**Town of Kittery
Planning Board Meeting
March 23, 2023**

ITEM 2 – 39 Badgers Island, Sketch Plan Review – Minor Cluster Subdivision

On behalf of BIW Group LLC – Owner and **Otter Creek Homes - Applicant** we submit herewith the attached package for **Final Subdivision Approval** at the March 23, 2023, Planning Board Meeting. In support thereof, we are submitting a revised Site Plan set with the associated revisions as needed to address the comments from CMA Engineers, along with this letter explaining the changes. The specific comments from the CMA letter are repeated below; with our response in **bold** text:

DEMOLITION PLAN C5

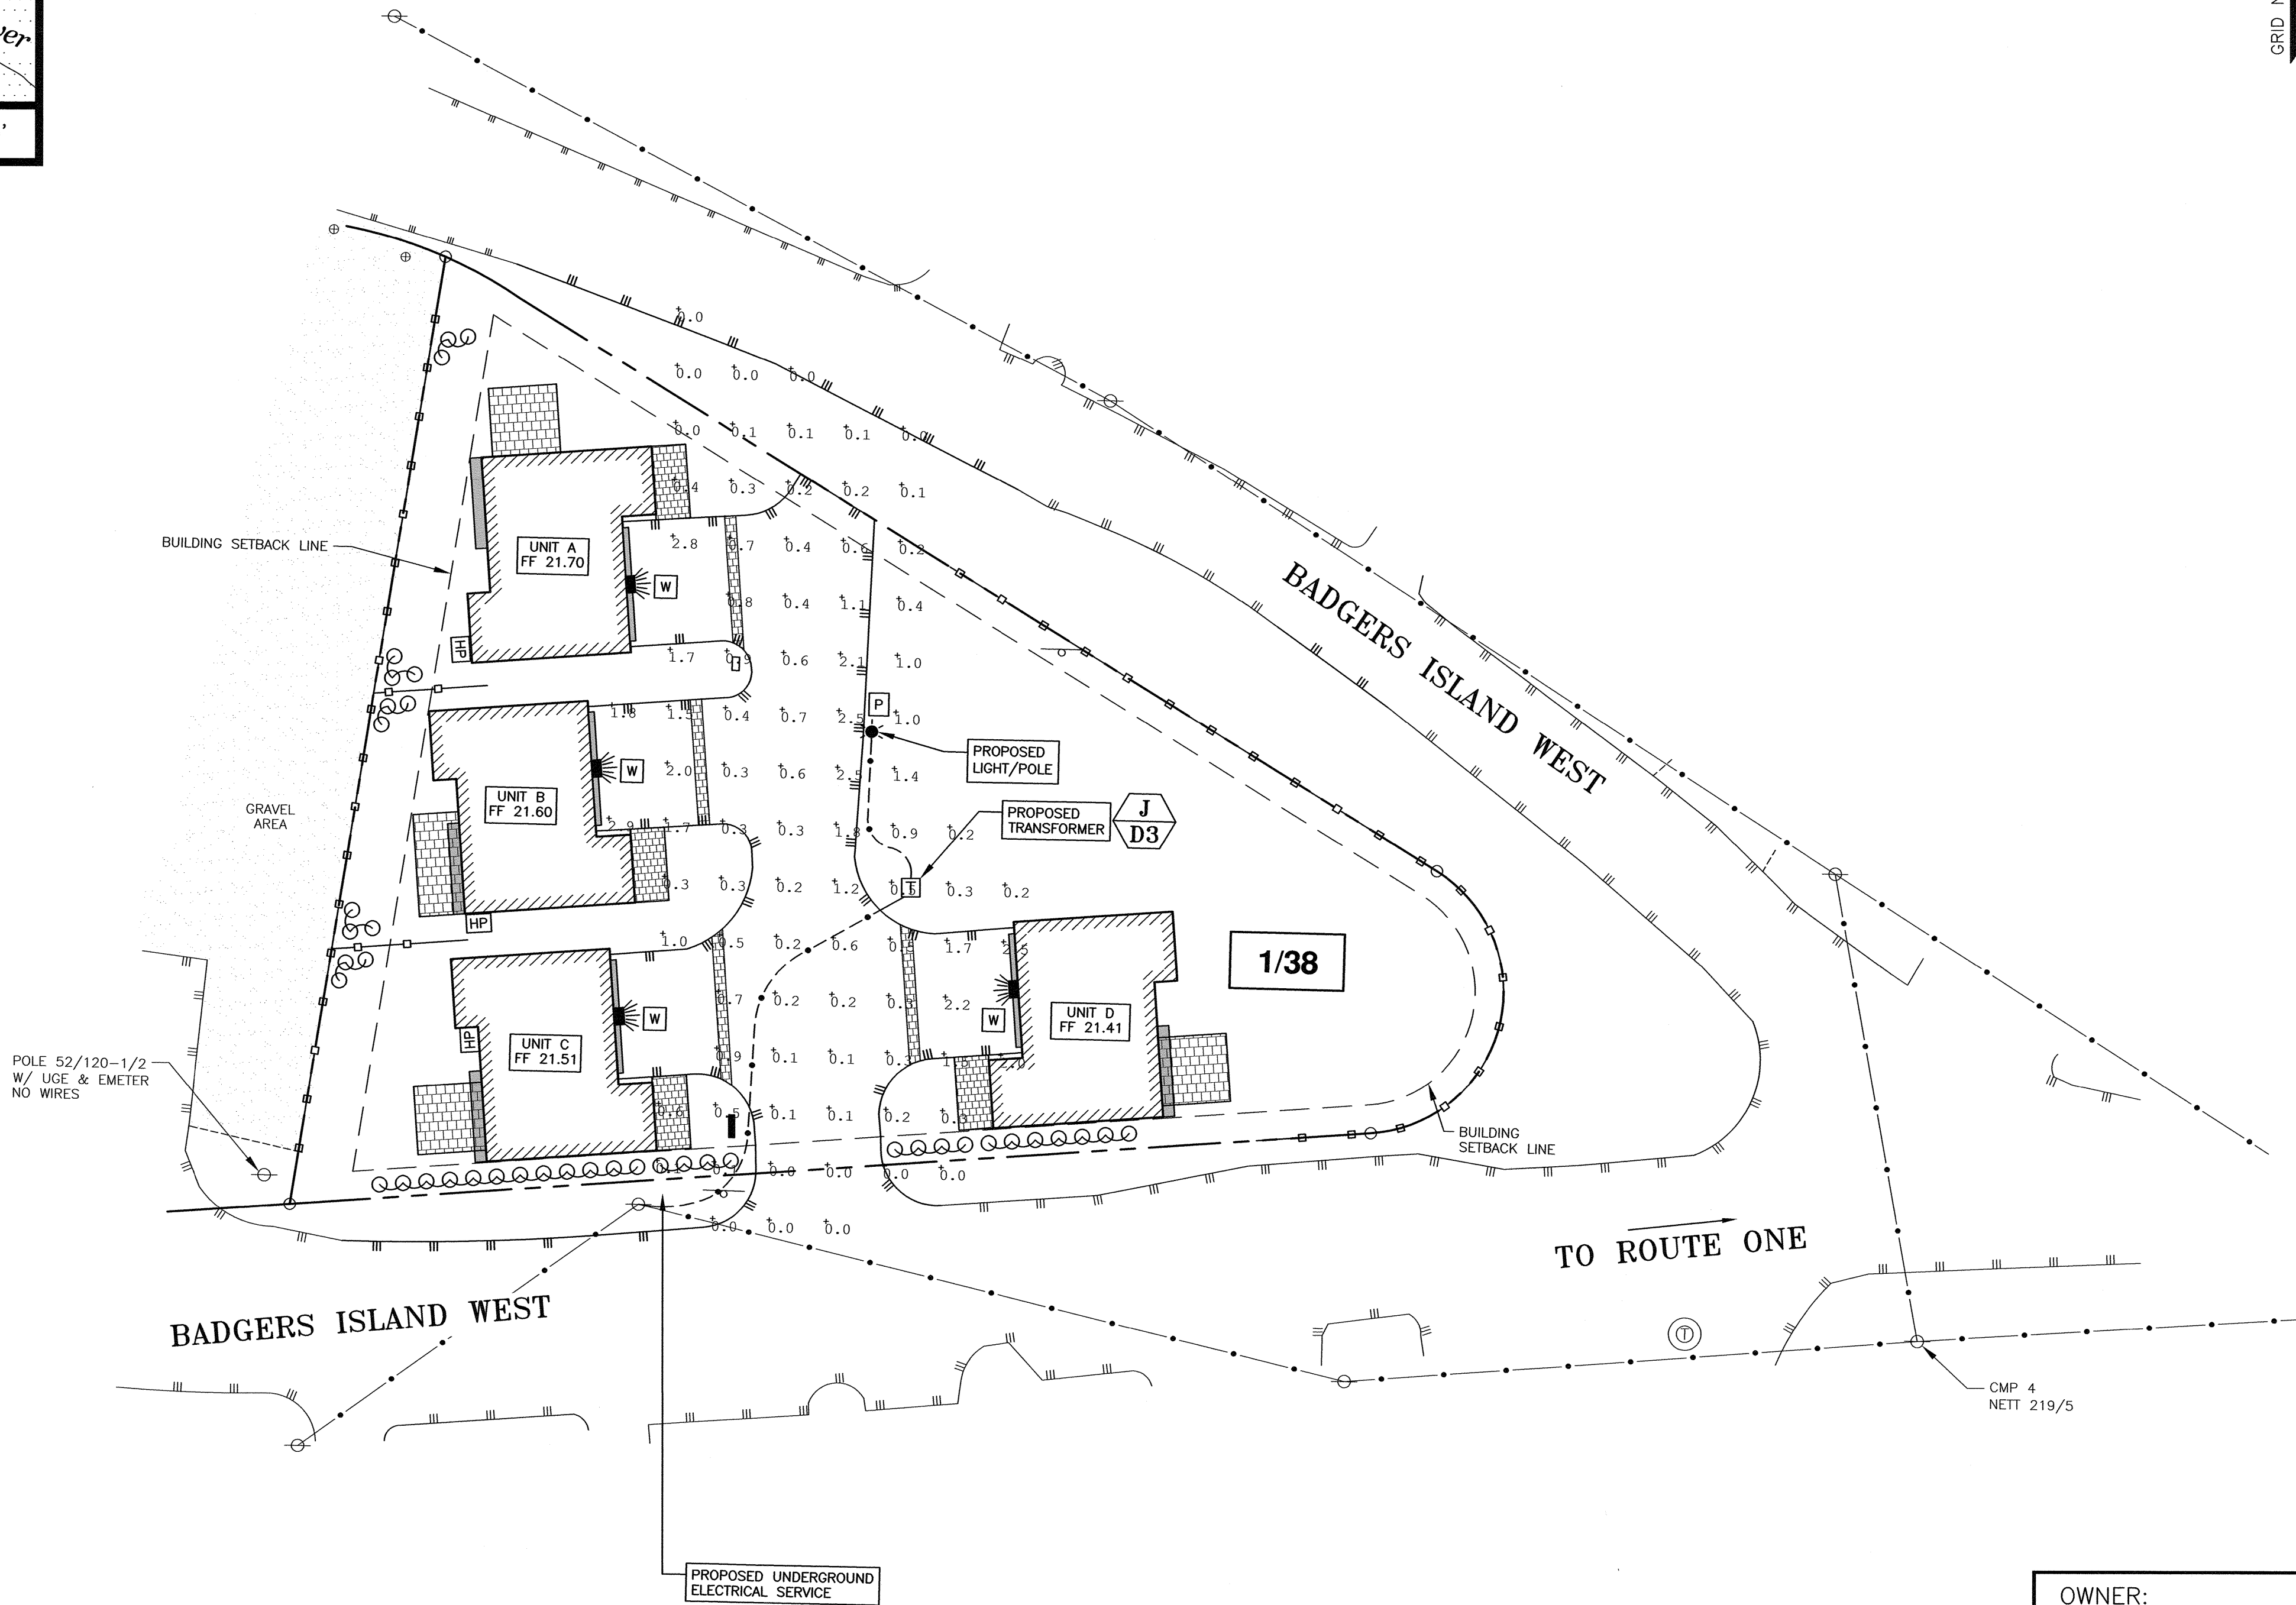
1. Should the sheet be printed partially in color or all black and white? **The plan shows color for the landscape elements which highlights this important part of the application. We prefer to leave the plan as is.**

K
C3 SEWER CHIMNEY
NOT TO SCALE

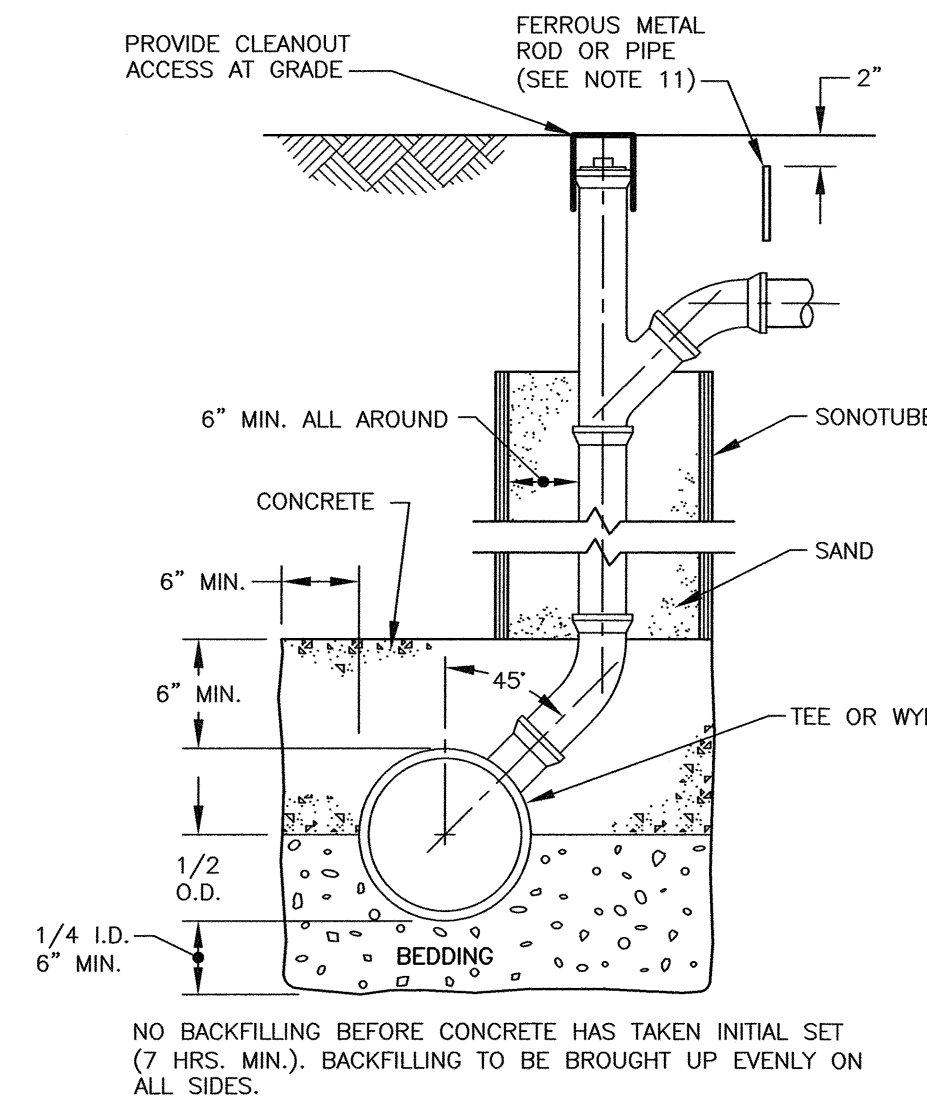
1. The sewer service size and type should be indicated. **Completed – see schedule.**
2. The water service and sprinkler service materials should be indicated. **Completed -see note.**
3. The sewer on site shows an external drop outside of the manhole near where the service ties into the existing main. Has Kittery sewer services approved an external drop? Alternatively, should the drop be located in SMH A, or another manhole be placed for the drop? **The sewer main in the street is deep; we propose to run the sewer on site at a minimal depth and then provide a**

chimney prior to the connection at the main. We revised the chimney detail to show the cleanout at finish grade.

M
C3 TYPICAL SEWER MANHOLE
NTS

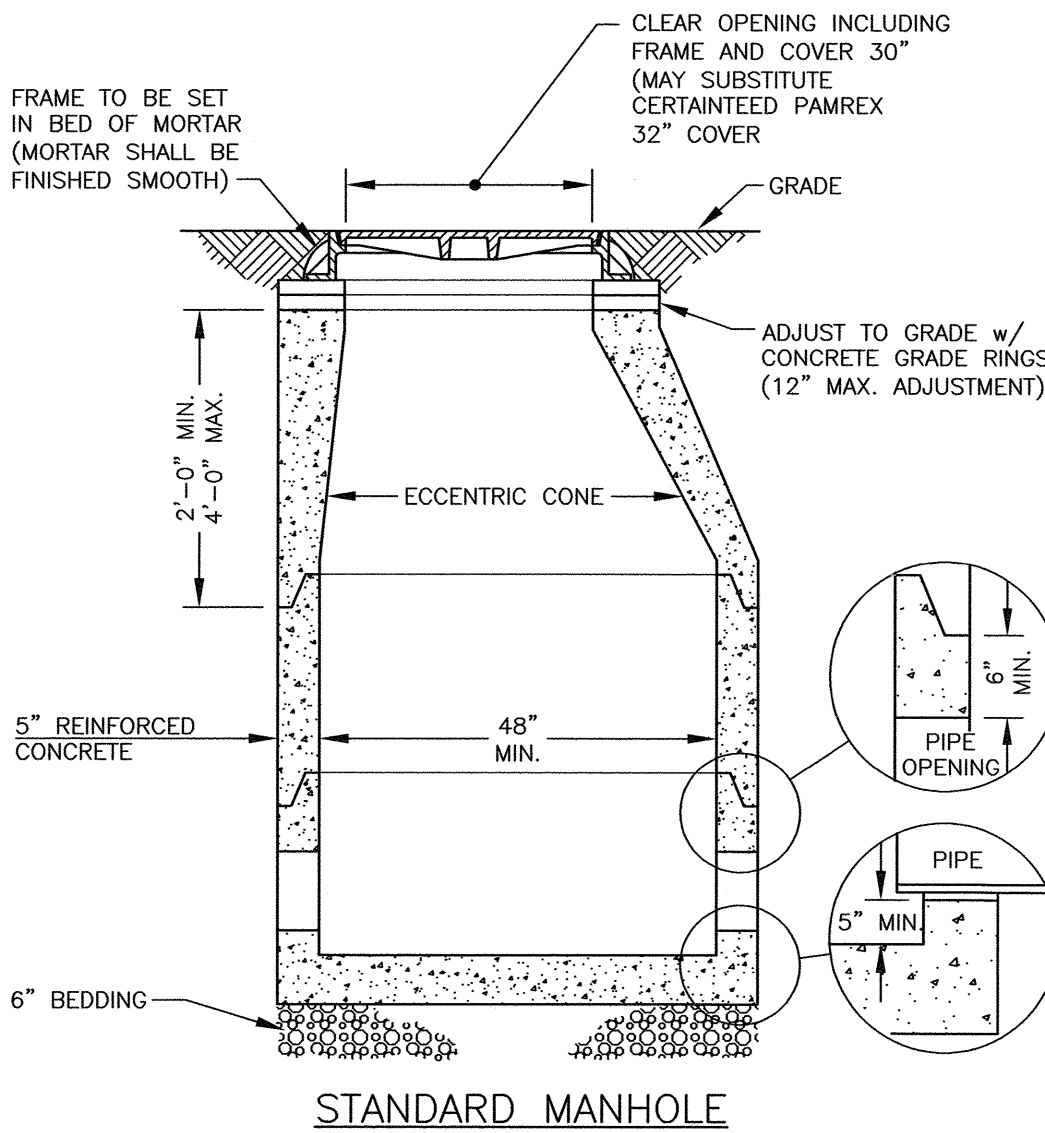
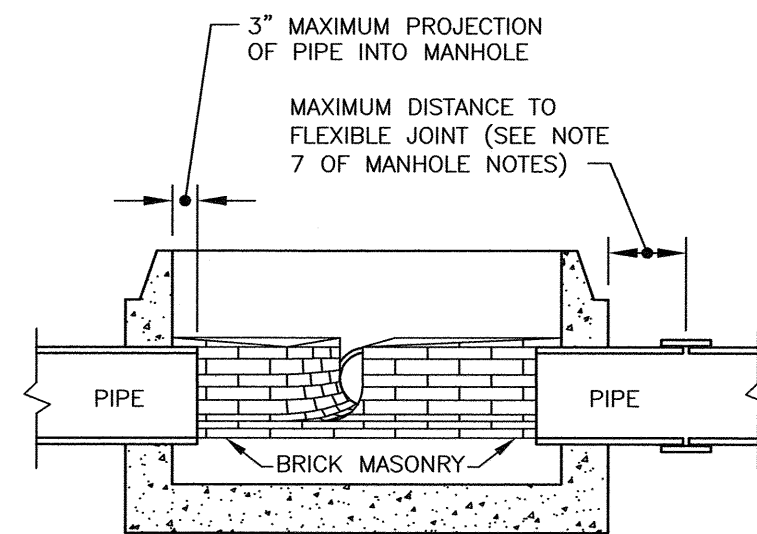
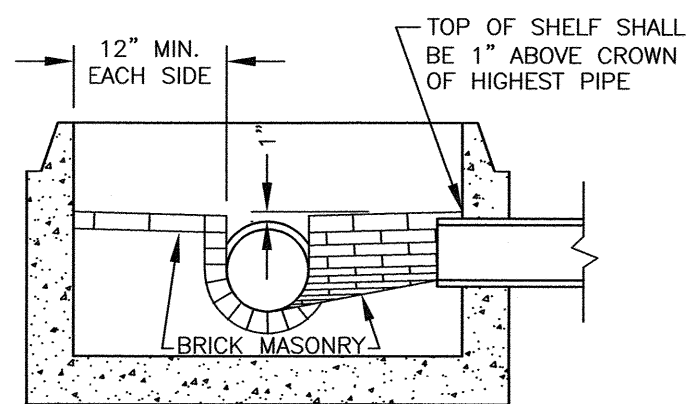
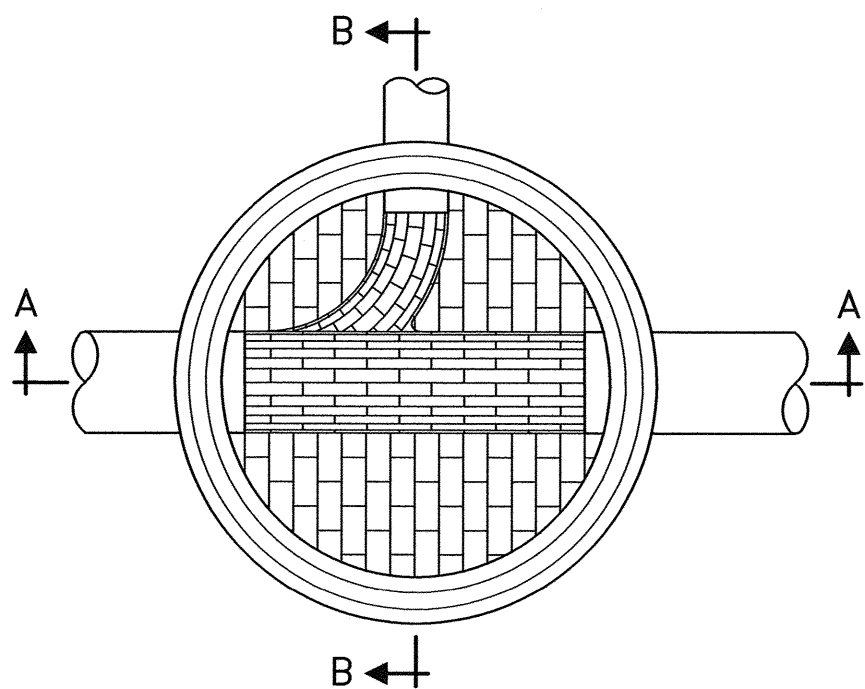
1. Sewer chimney and sewer service connections should be approved by KSS. **This review can be a part of the connection permit. Also see added Note 4.**
2. A sewer manhole detail should be provided. **Completed.**
